Minutes

Planning Committee

Wednesday 5 April 2023 6pm

Figure 1. Ground floor comparison of existing adjoining dwelling (12A Long Street) on left and proposed dwelling at 12B Long Street (right).

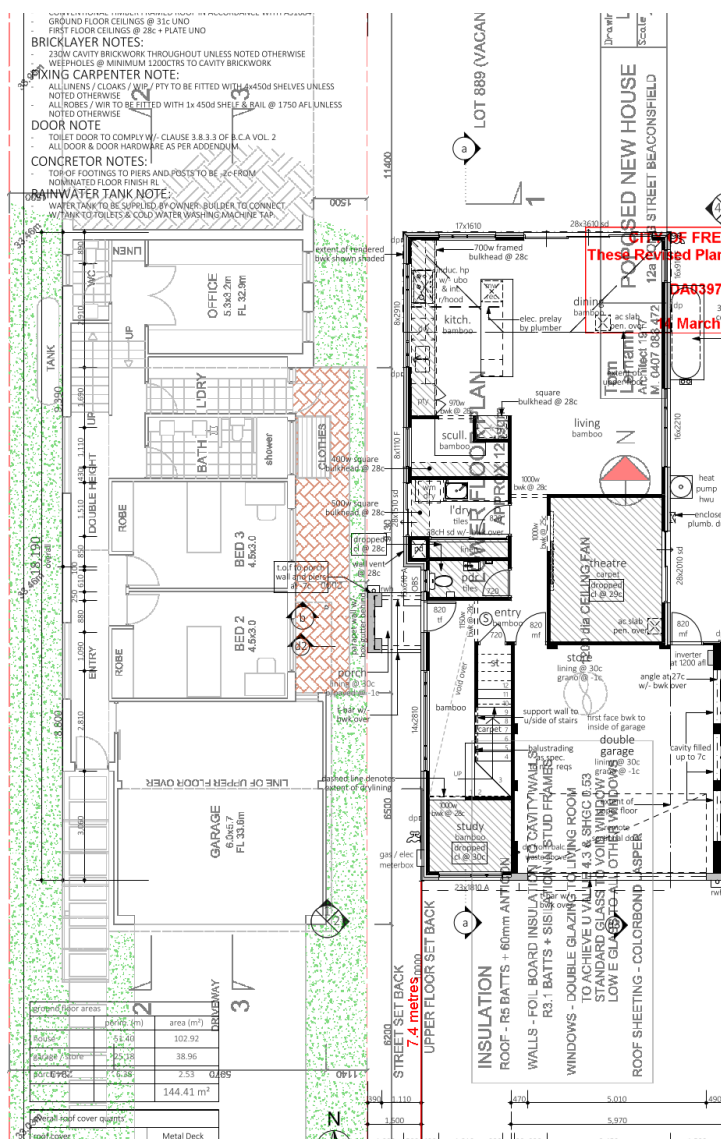
- With a wall height of less than 3.5m as measured from the natural ground level at the shared boundary, the proposed wall is not considered to impose unacceptable building bulk on the adjoining property (12A Long Street);
- The wall is not to be opposite any area of outdoor living area of the adjoining property and will be predominantly opposite the Bath, Laundry and Office of this adjoining dwelling (see images below) which are not considered sensitive habitable rooms;
- Given the north-south orientation of the lots, the lesser setback does not contribute adversely to a loss of direct sun or natural light generally, nor unacceptably reduce ventilation to major openings given the setback of the eastern neighbour which shall provide adequate separation between the dwellings; and

- The lesser setback does not result in any new merit-based decision relating to visual privacy as the FFL is not more than 500mm above the natural ground level at the boundary.

Figure 2. Upper floor comparison of existing adjoining dwelling (12A Long Street) on left and proposed dwelling at 12B Long Street (right).

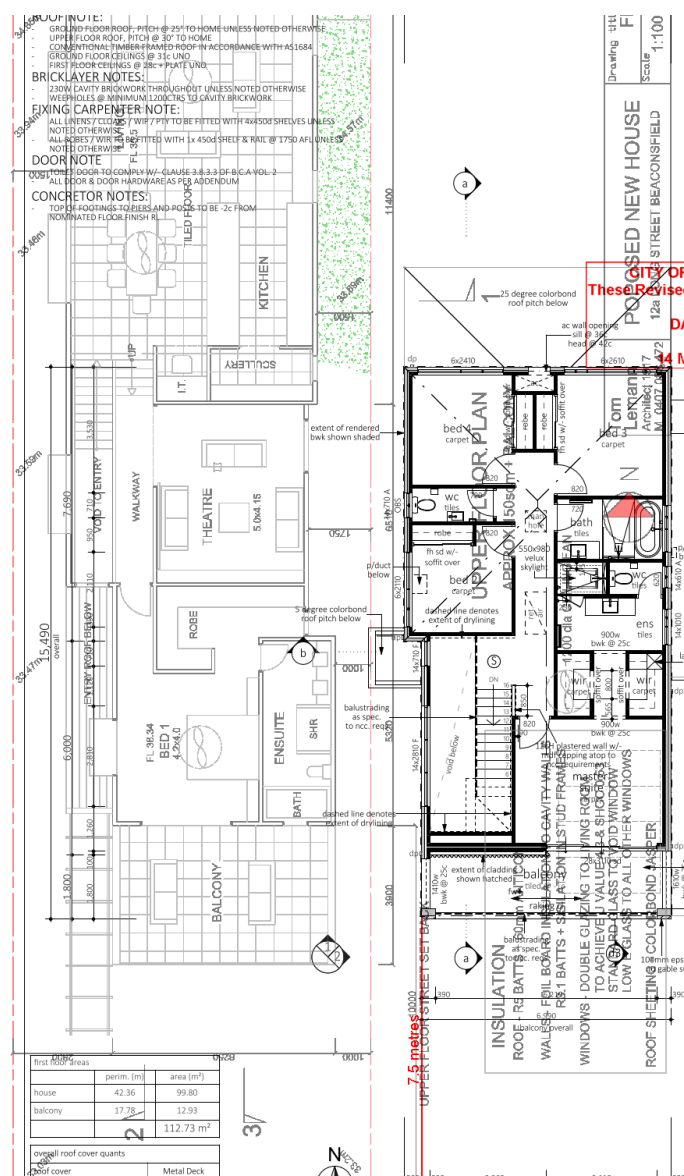
The eastern lot boundary setback of the Upper Floor Bed 4-Bed 2 wall is considered to meet the design principles of the R-Codes in the following ways:

- The lot boundary setback variation is minimal at only 150mm and is proposed in a location that will not be opposite any sensitive major openings (being opposite either blank walls, the theatre and scullery of the adjoining dwelling) nor outdoor living areas of the adjoining eastern property (see image below). As such, the proposed wall is not expected to

- cause adverse building bulk impacts upon any sensitive areas of this adjoining dwelling;
- Given the north-south orientation of the lots, the lesser setback does not contribute adversely to a loss of direct sun or natural light generally, nor unacceptably reduce ventilation to major openings given the setback of the eastern neighbour which shall provide adequate separation between the dwellings; and
- No major openings are proposed within the wall and thus, the wall setback does not result in any new merit-based decision relating to visual privacy.
